STATE OF NORTH CAROLINA
DEPARTMENT OF TRANSPORTATION

Minutes of Pre-Bid Conference

PROJECTS: WBS 33203.3.1 (B-3657) Haywood County Bridge No. 9

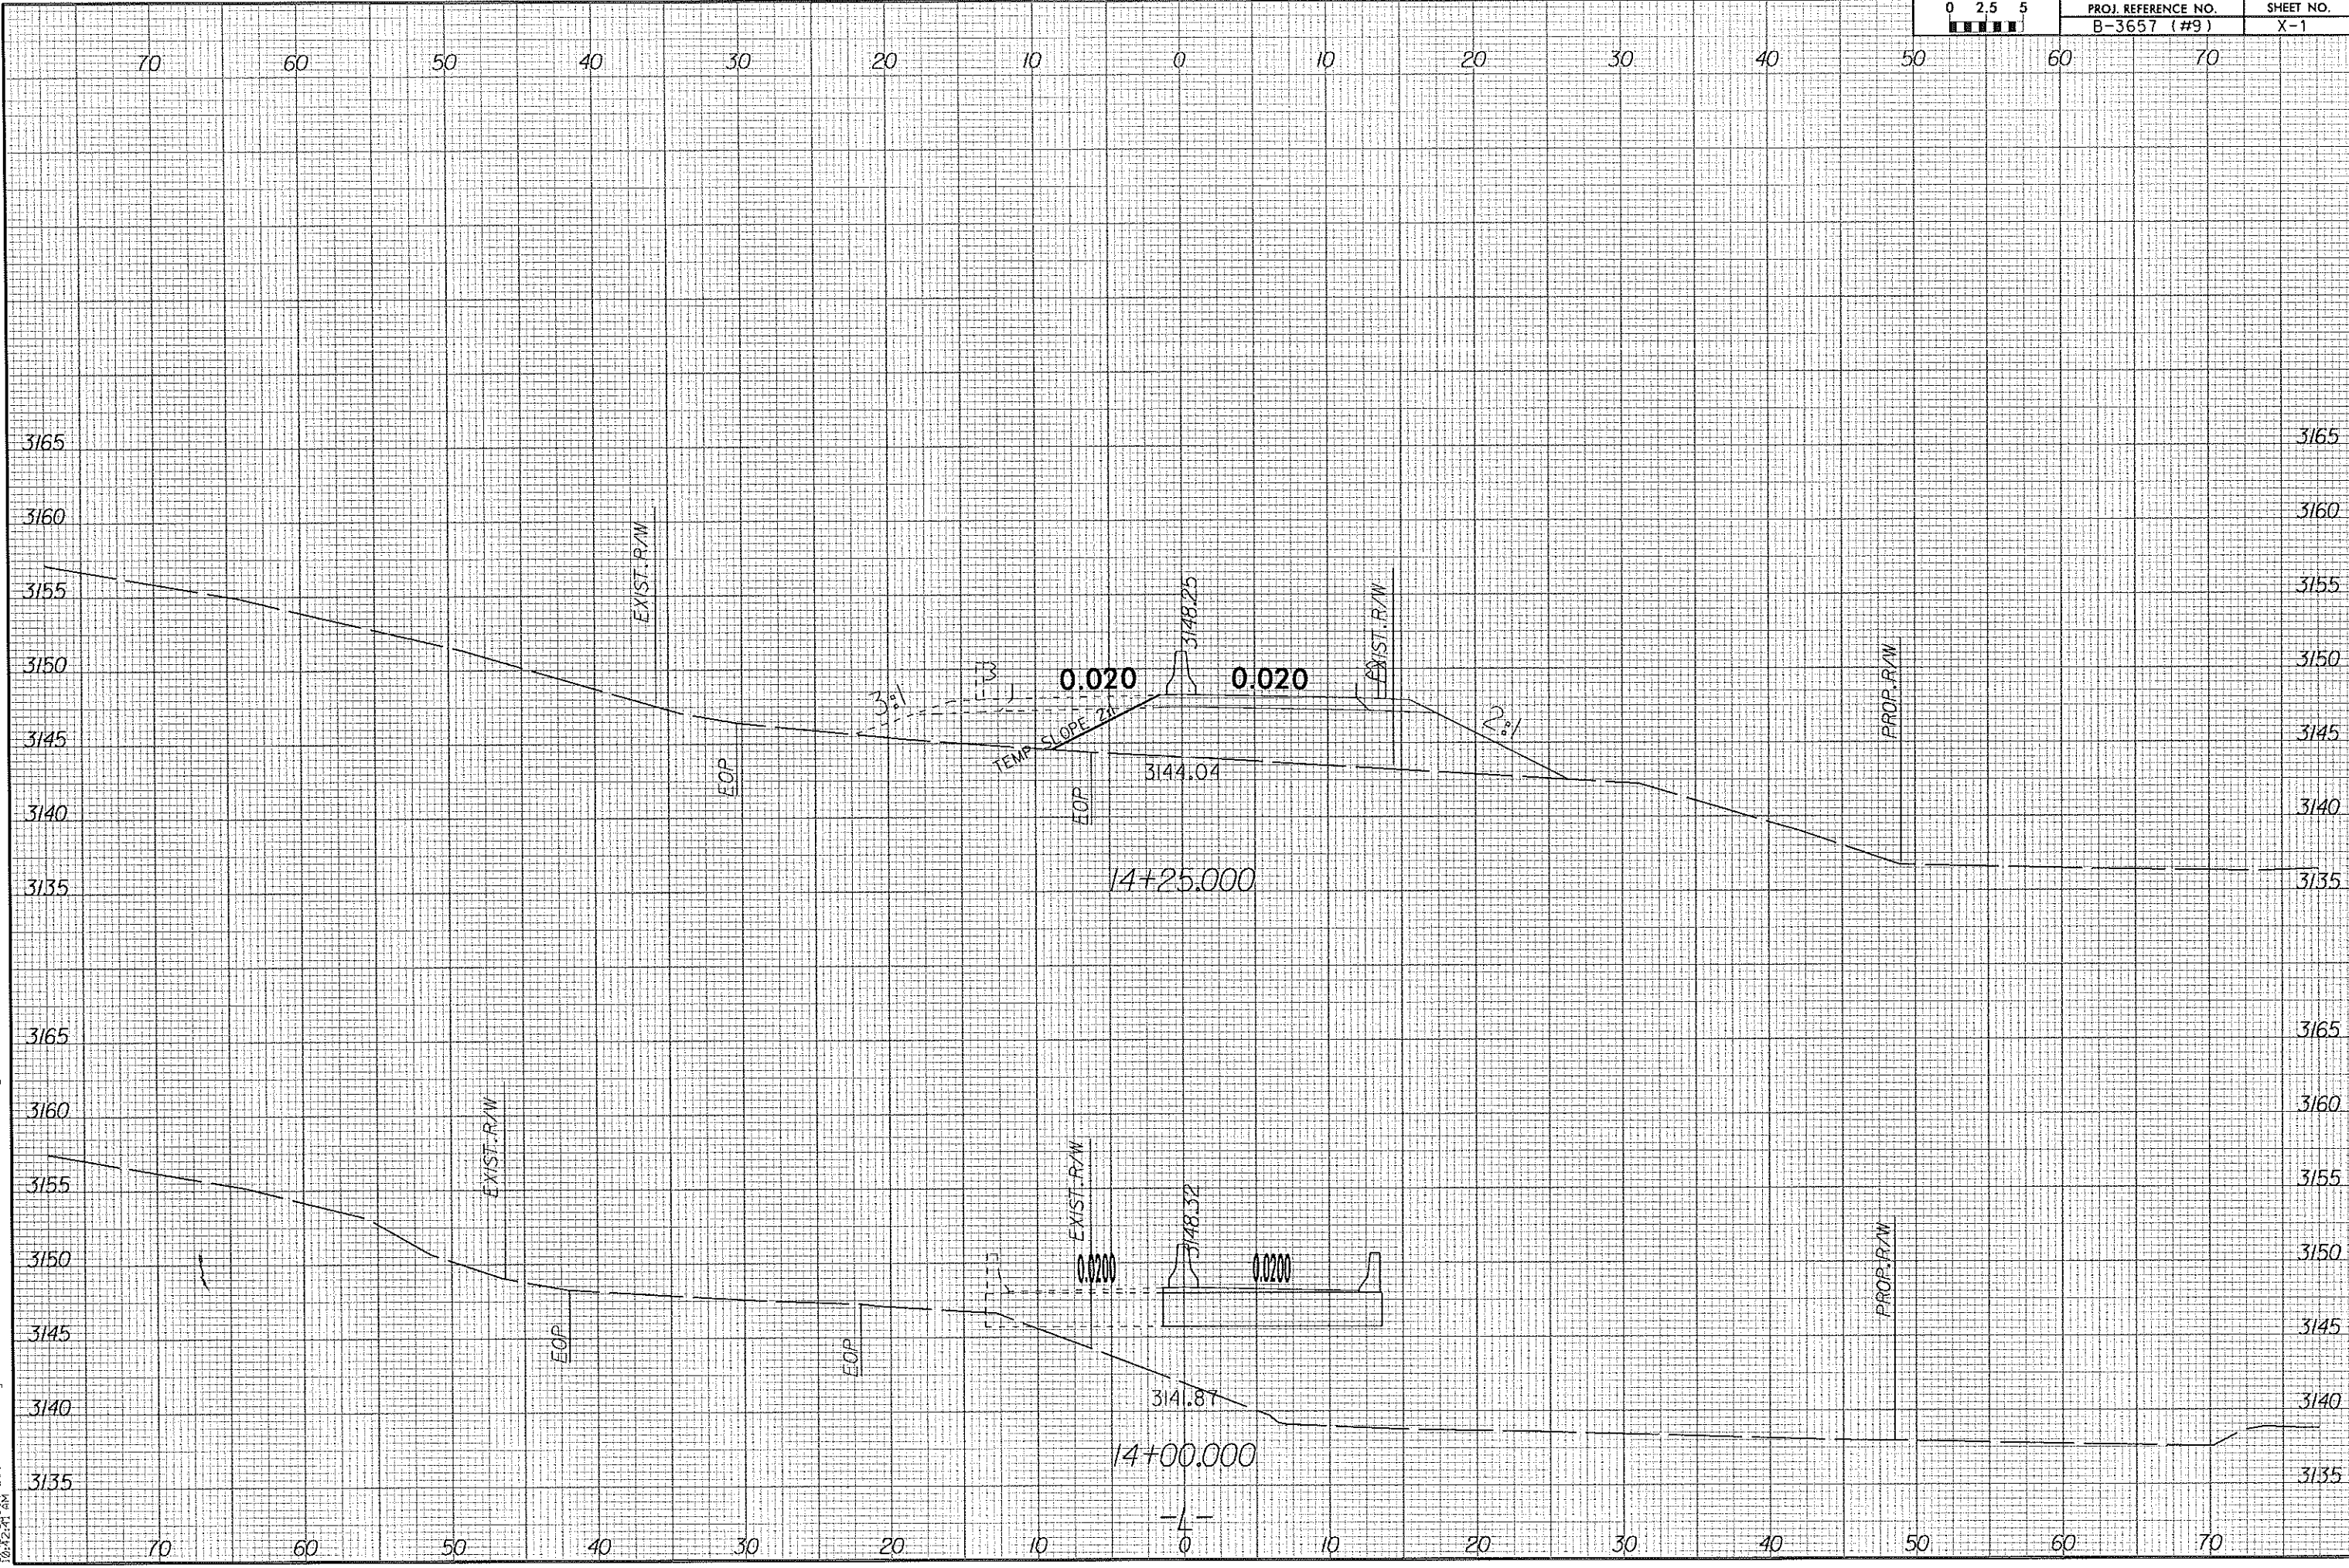
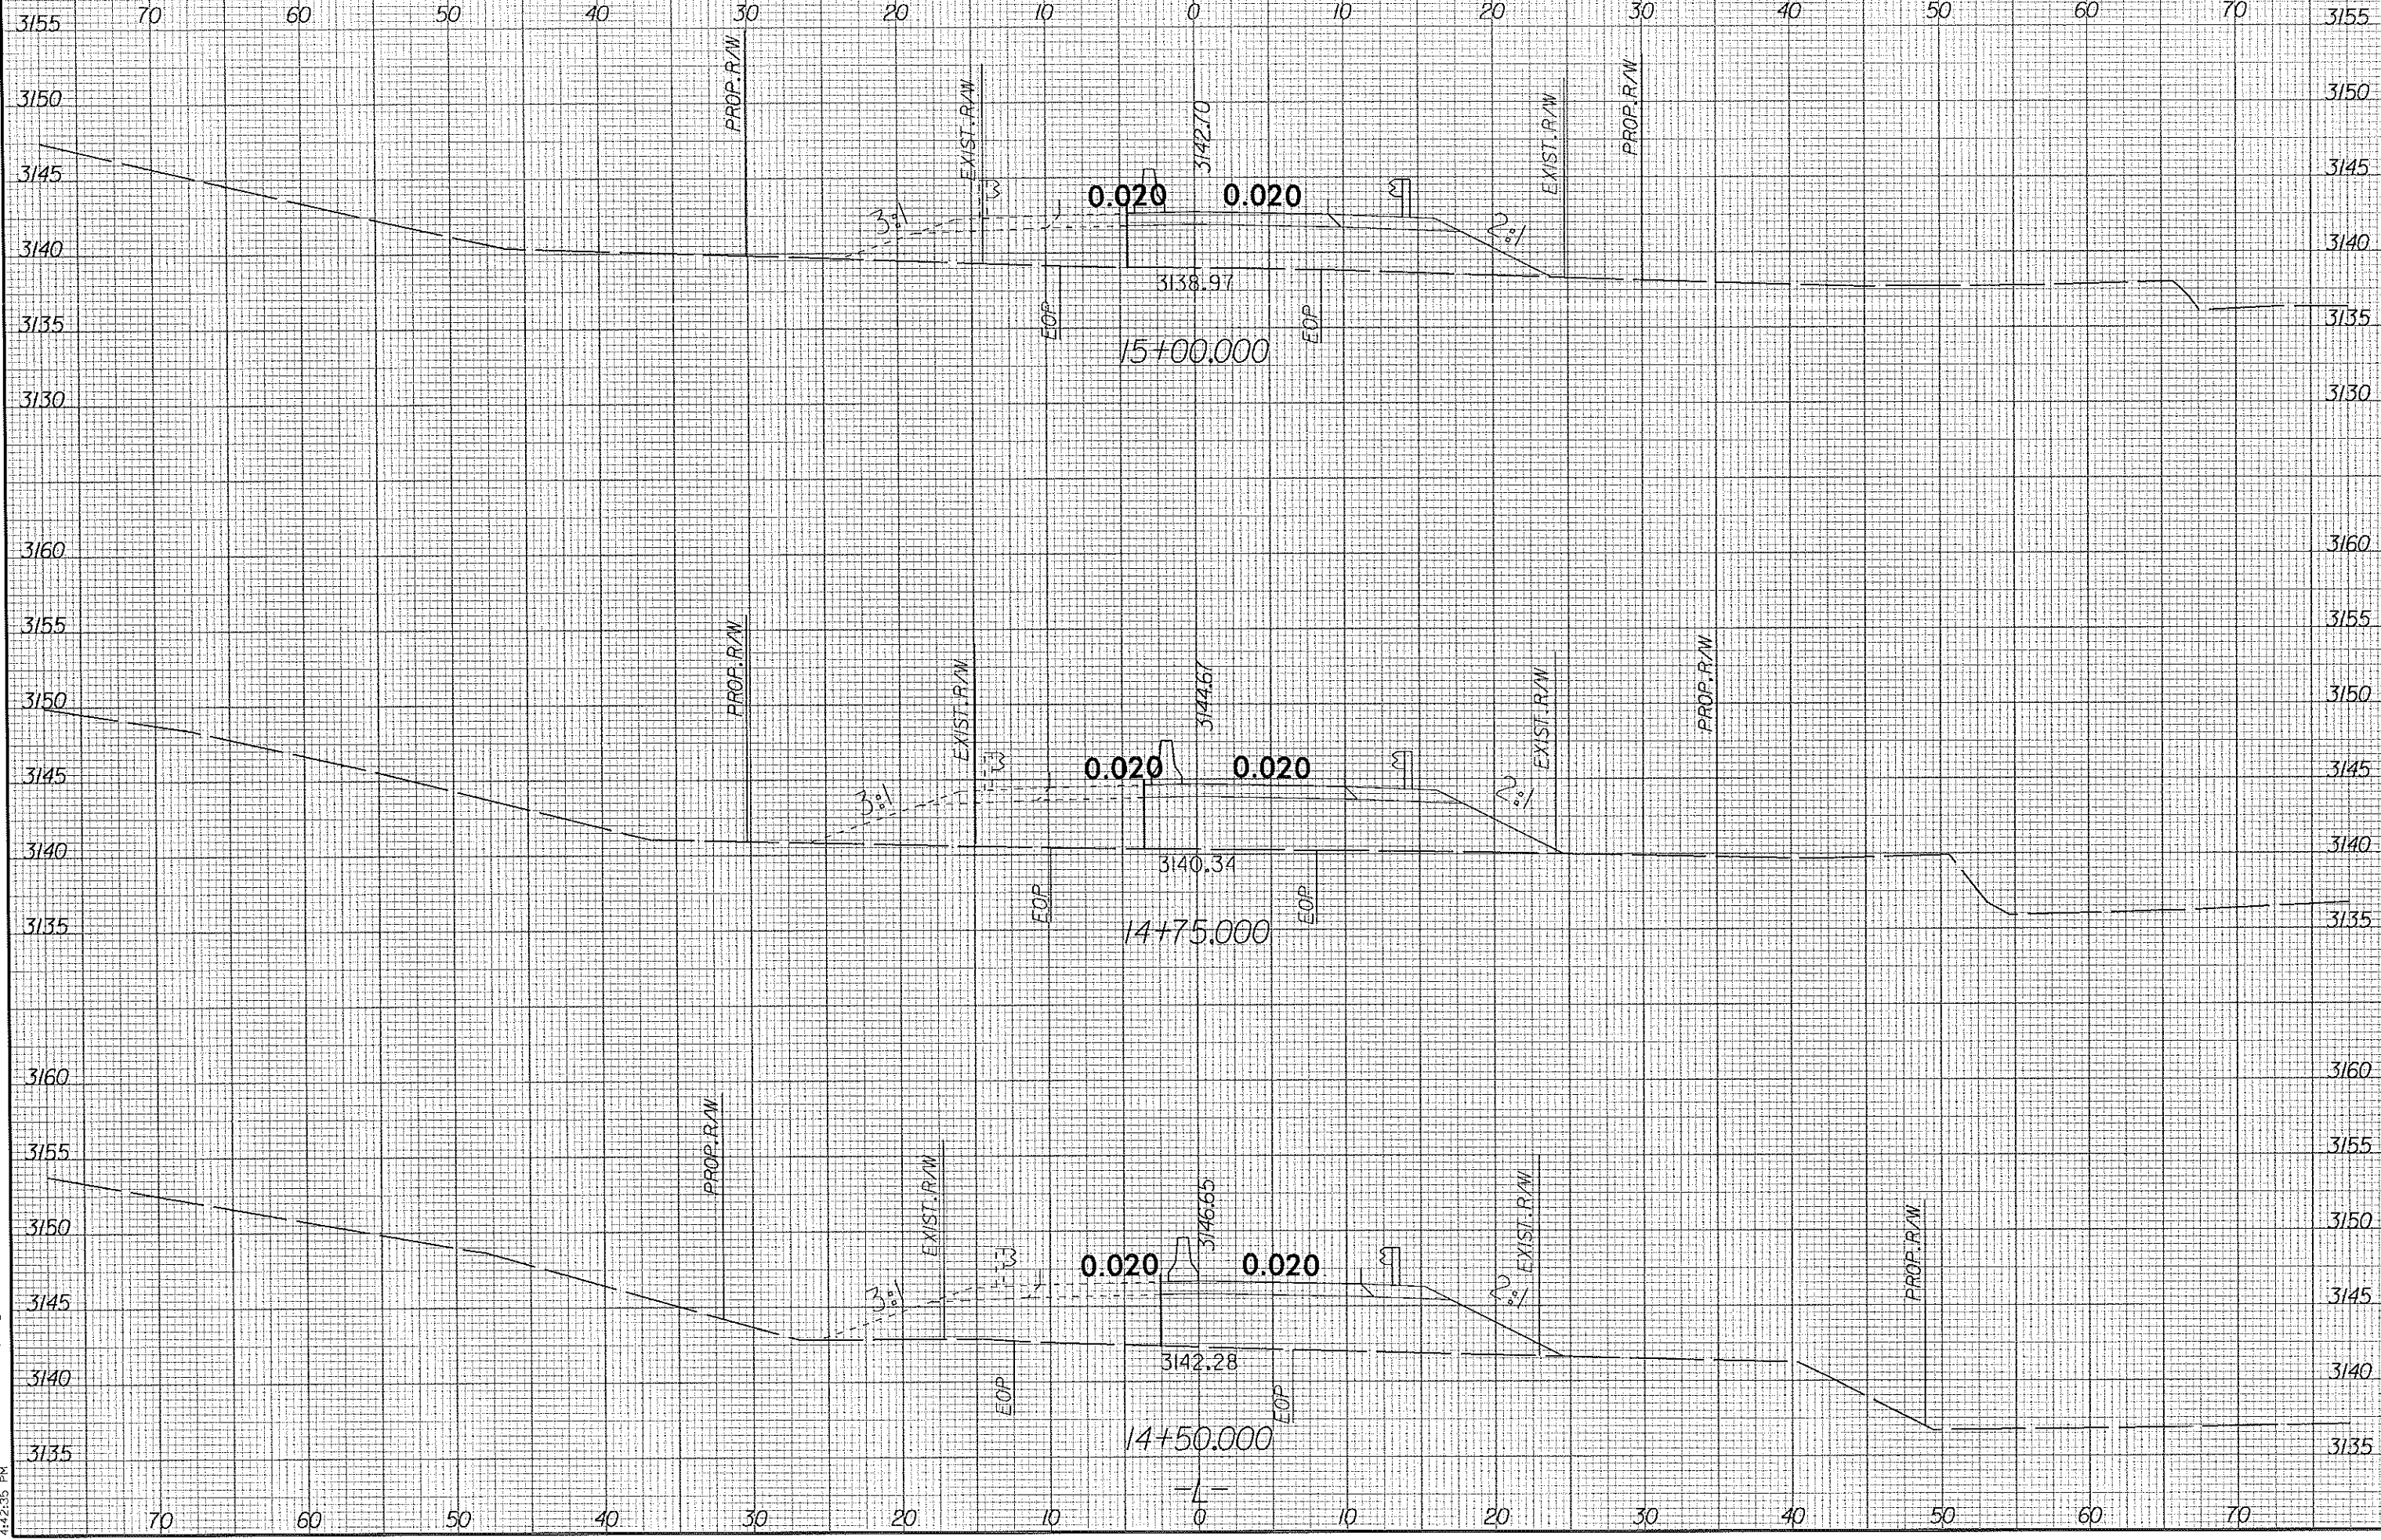
2. The contractors were informed that the backfill detail had been added to plans. Sheet no. 2 had been revised to show the 4” perforated drain pipe and outlet pad for the backfill. Based on contractor questions since the pre-bid meeting the limits of the temporary shoring have been revised on the end bent 2 side of the project. The revised plan sheet no. 2 and revised bid sheet are attached to these minutes.
